# UNITED STATES PATENT AND TRADEMARK OFFICE

APPLICATION NO.	FILING DATE	FIRST NAMED INVENTOR	ATTORNEY DOCKET NO.	CONFIRMATION NO.
10/809,210	03/25/2004	Paul E. Freude	ITFT-PEV104US	6561
23122	7590	11/30/2005	EXAMINER	
RATNERPRESTIA P O BOX 980 VALLEY FORGE, PA 19482-0980			COOLEY, CHARLES E	
			ART UNIT	PAPER NUMBER
			1723	
DATE MAILED: 11/30/2005

## **NON-FINAL OFFICE ACTION**

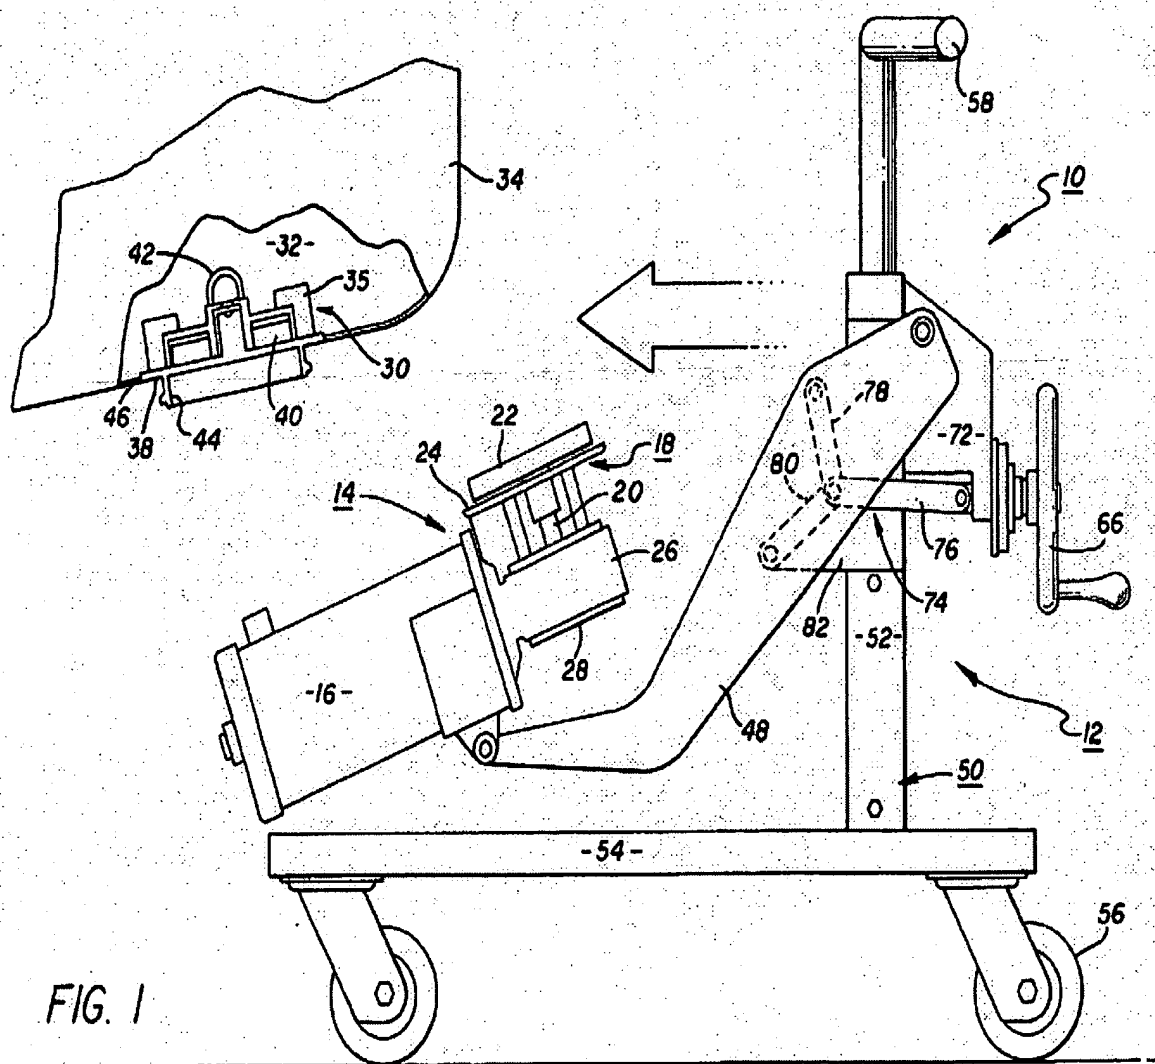
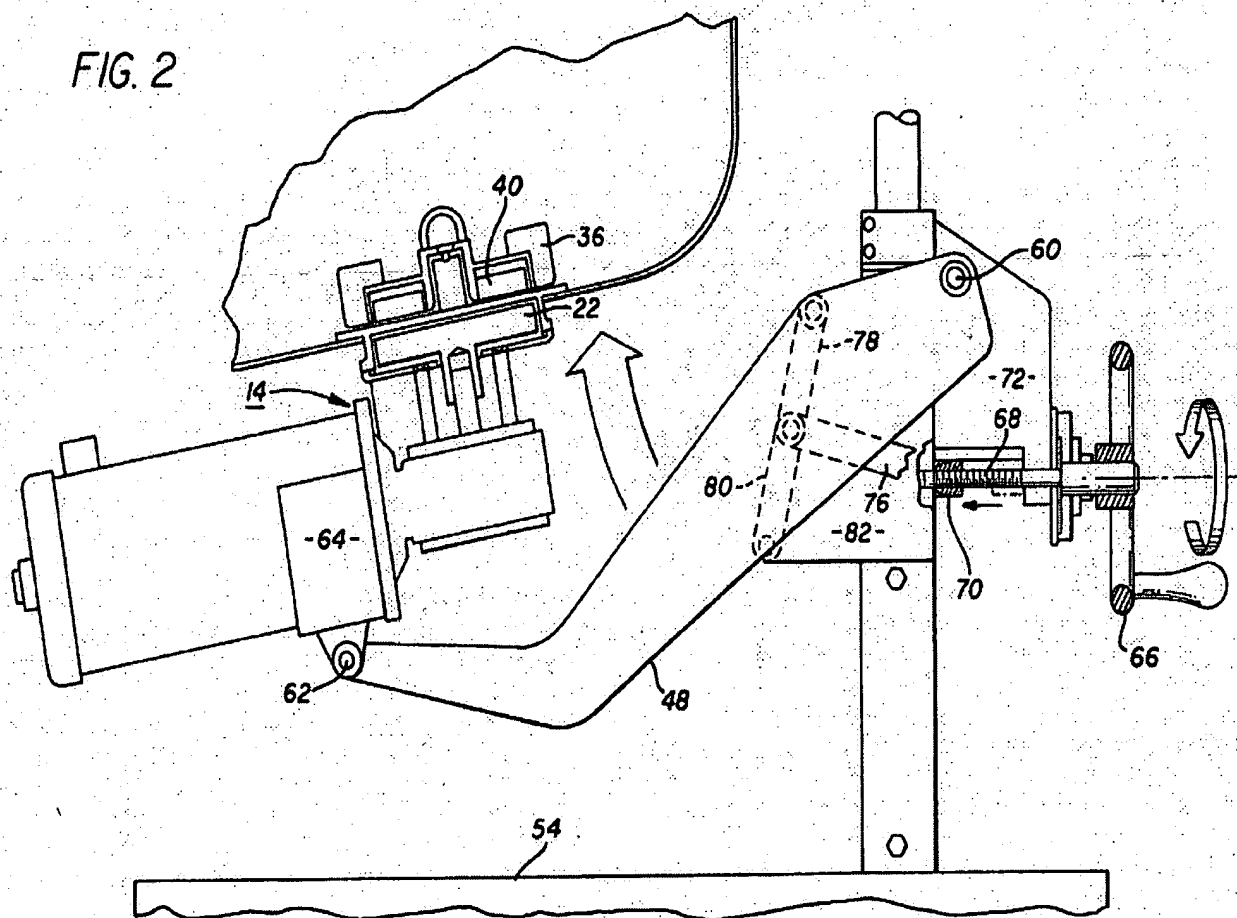
10. **Claims 1-4, 9-10, 15, 19, 20-21, 26-29, 36, 38, 40, and 41 are rejected under 35 U.S.C. 102(b) as being anticipated by Rains (US 5,378,062).**

The patent to Rains (US 5,378,062) discloses a method and a system as seen in the Figures below comprising a tank 34; a bottom mount mixer 30 in the tank; a mixer magnetic coupling 40 with a shaft (below 42); docking station 12 with a mixer drive 16, 28, 18 with a magnetic coupling 22; the docking station having a cantilevered linkage 74; tank receiving member 38; tank engagement facilitating component 44 or latch portions 24, 44 which mate with each other as seen in Fig. 2; support frame 50; the docking station having a bottom plate 54 with wheels 56; components 48, 76, 78, 80 for maintaining engagement between the tank and the docking station.
